**Subject: Submittal of the Response to the Notice of Disapproval for the 2012 Monitoring Plan for Los Alamos and Pueblo Canyons Sediment Transport Mitigation Project and Revision 1**

**Response to the Notice of Disapproval for the 2012 Monitoring Plan for  
Los Alamos and Pueblo Canyons Sediment Transport Mitigation Project,  
Los Alamos National Laboratory, EPA ID No. NM0890010515, HWB-LANL-12-016,  
Dated April 16, 2012**

# **2012 Monitoring Plan for Los Alamos and Pueblo Canyons Sediment Transport Mitigation Project, Revision 1**

Figure 2.0-1 Los Alamos and Pueblo canyons showing monitoring locations and sediment transport mitigation sites

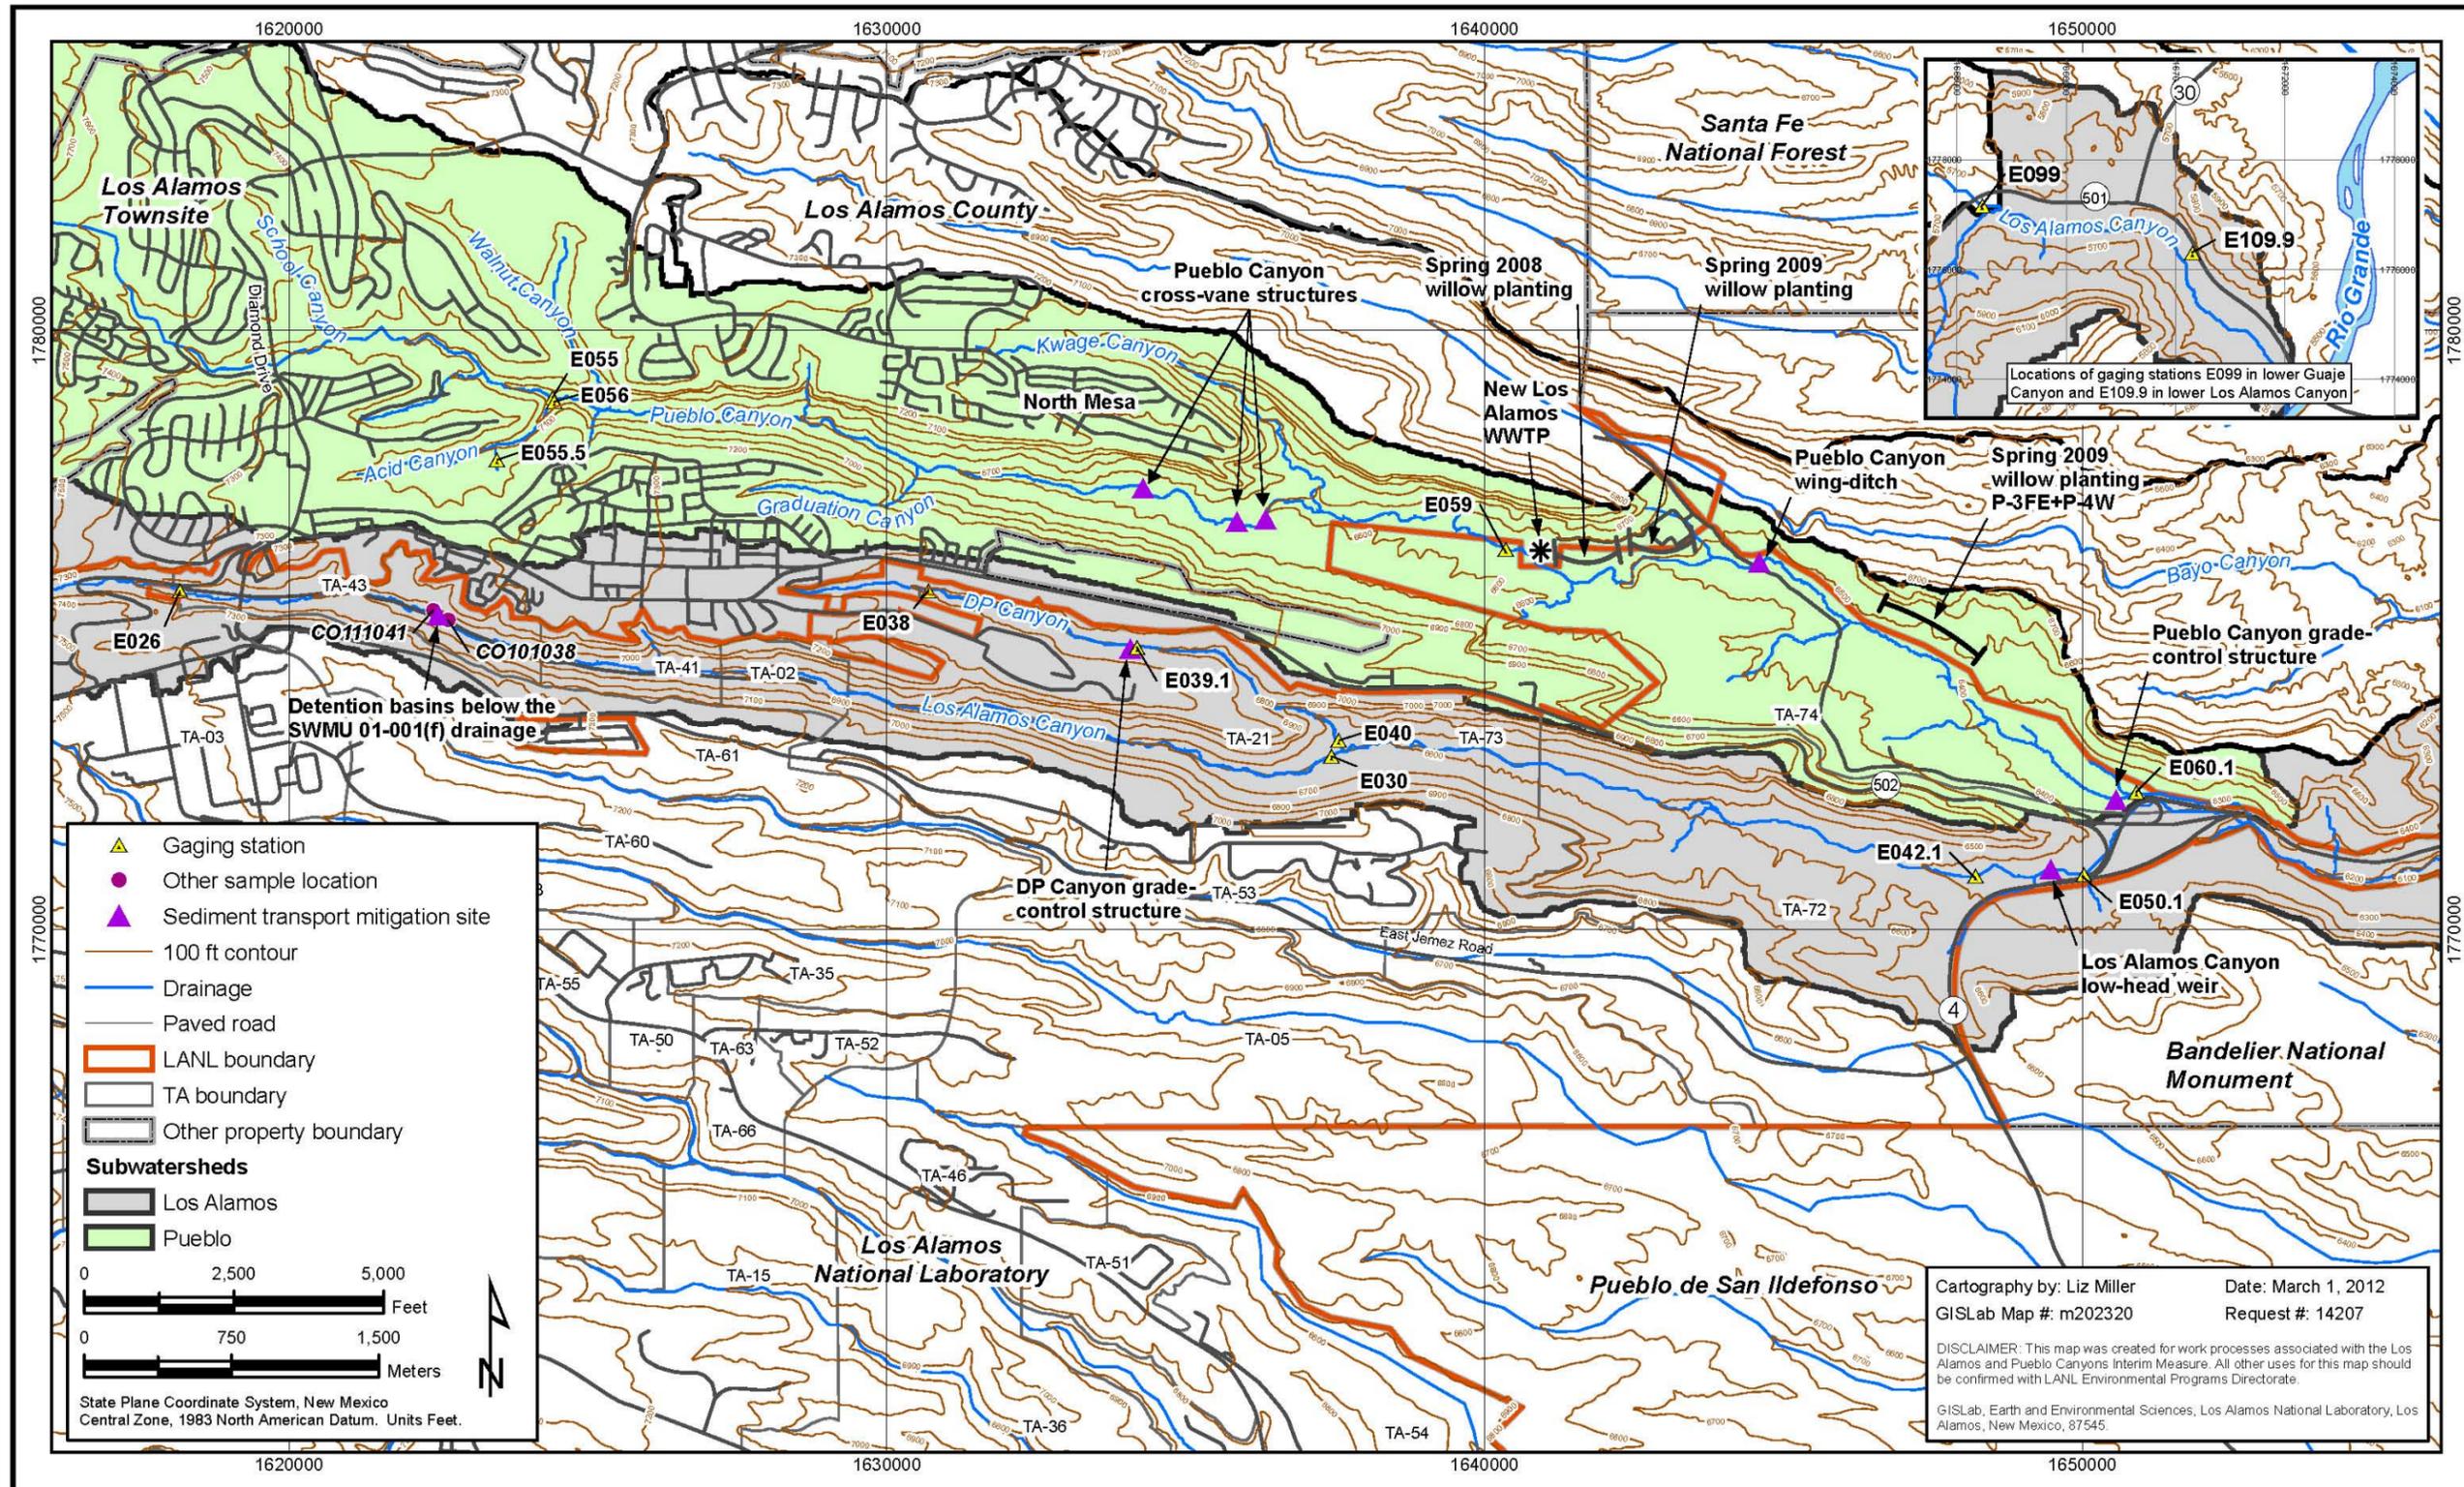
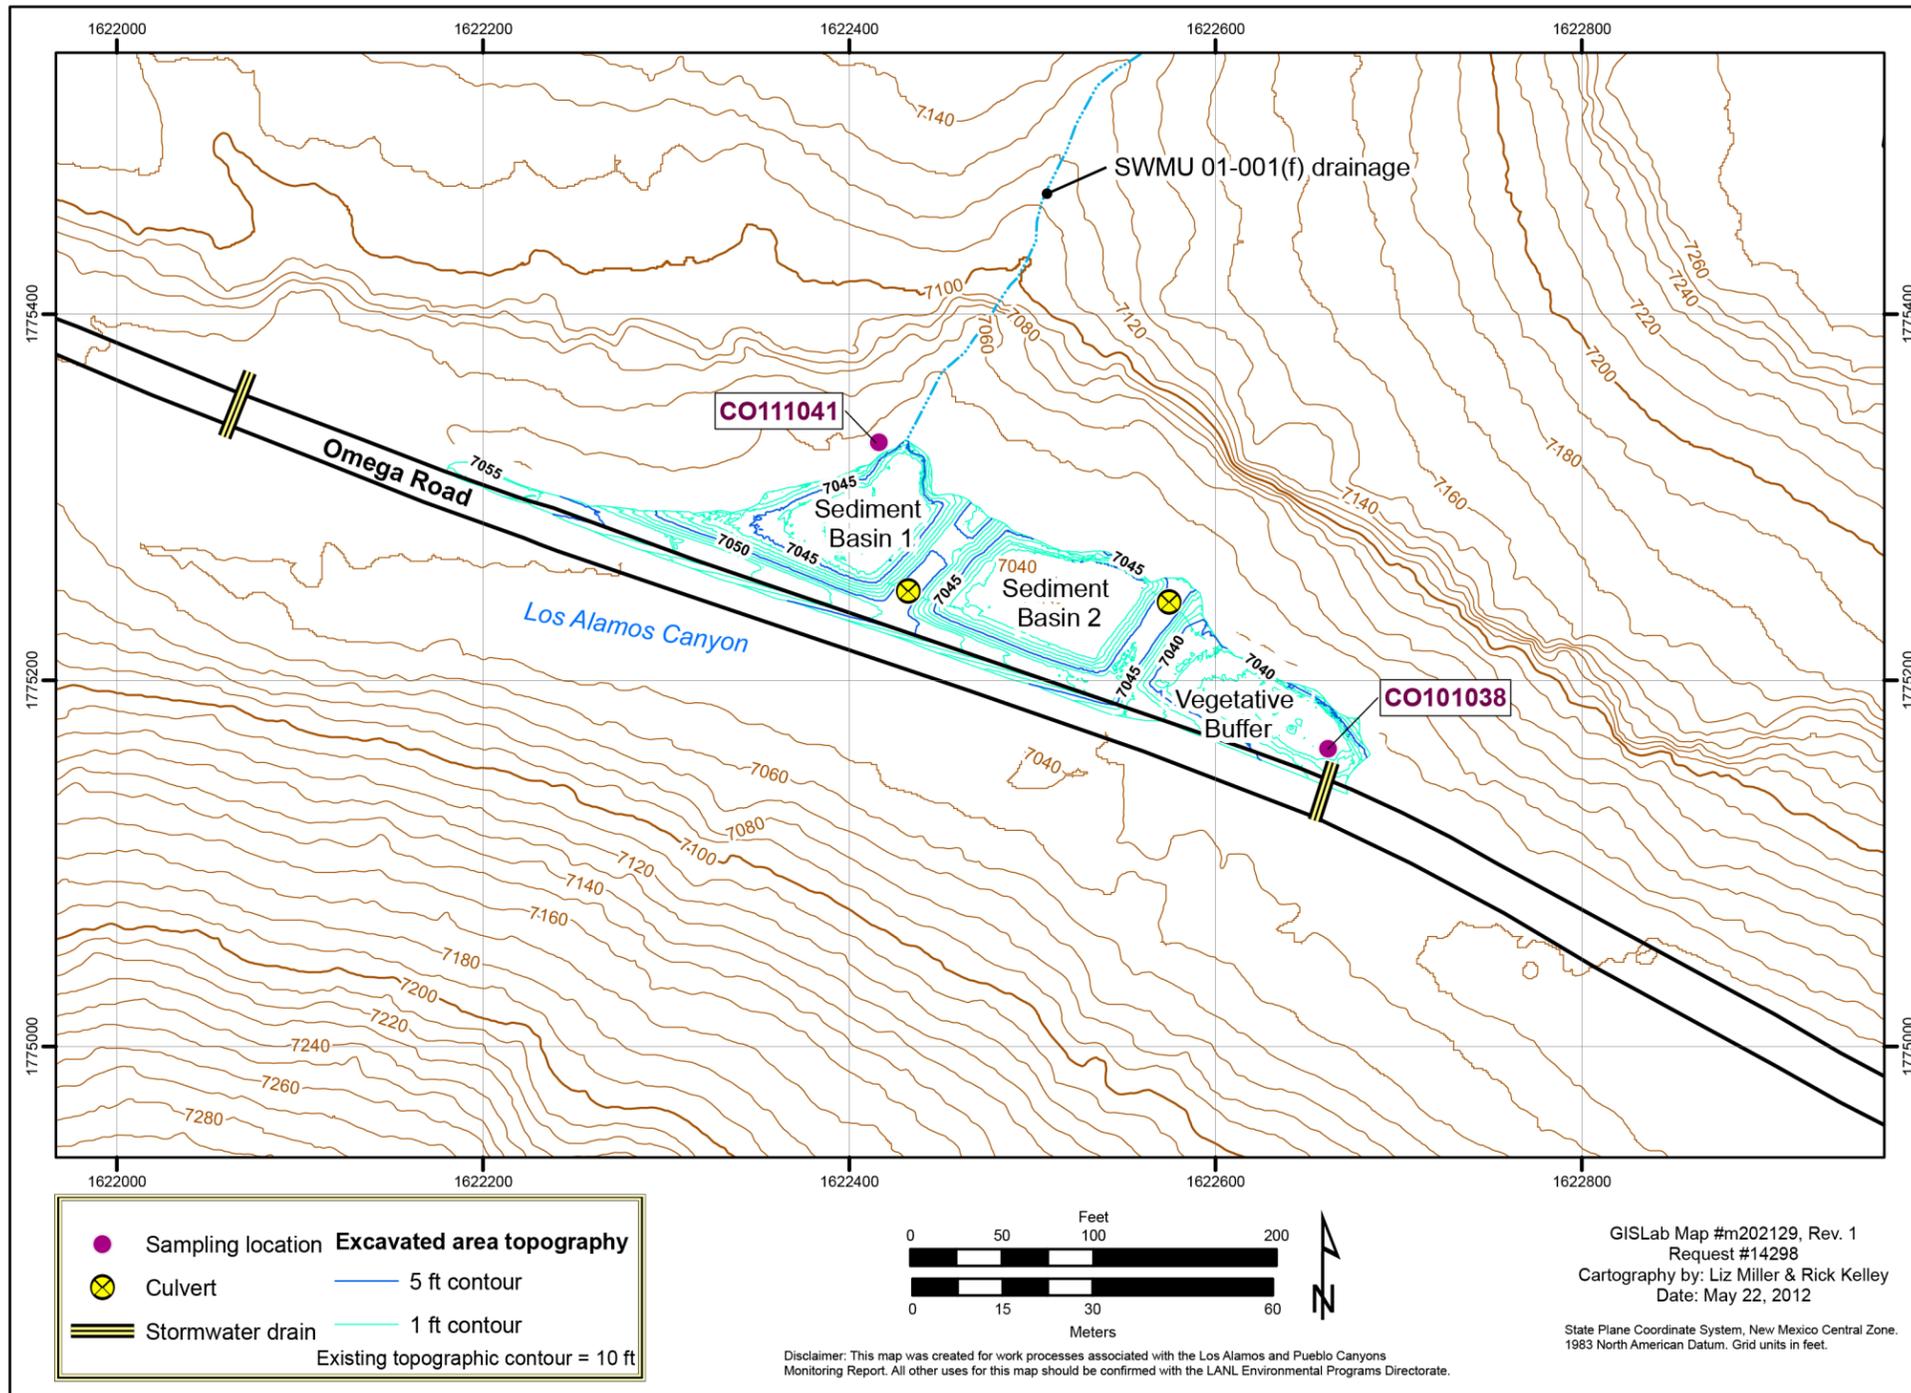
**Permittees’ Statement:** “As directed in the approval with modifications for the 2011 monitoring plan (NMED 2011, 203705), sampling was conducted in Graduation Canyon during 2011. The results of these analyses were reported in the March 2012 “Stormwater Performance Monitoring in the Los Alamos/Pueblo Watershed during 2011” (LANL 2012, 211396). Continued monitoring at this location is not proposed.”

**NMED Comment:** The data from this location was not evaluated in the Report and no reason is given in the Plan to discontinue sampling. The average level of PCBs in the suspended sediment at this

location in 2011 is the second highest of all the locations monitored and is second only to that below SWMU 01-001(f). Continue to monitor at this location. The Permittees may reduce the analytical suite to PCBs and SSC.

4. LANL will continue monitoring in Graduation Canyon and will reduce the analytical suite to polychlorinated biphenyls and SSC. The 2012 monitoring plan has been revised to include this sampling.

As directed in the approval with modifications for the 2011 monitoring plan (NMED 2011, 203705), sampling was conducted in Graduation Canyon during 2011 (location CO115002 on Figure 2.0-1). The results of these analyses were reported in the March 2012 "Stormwater Performance Monitoring in the Los Alamos/Pueblo Watershed during 2011" (LANL 2012, 211396). Monitoring for PCBs and SSC will continue at this location during 2012.
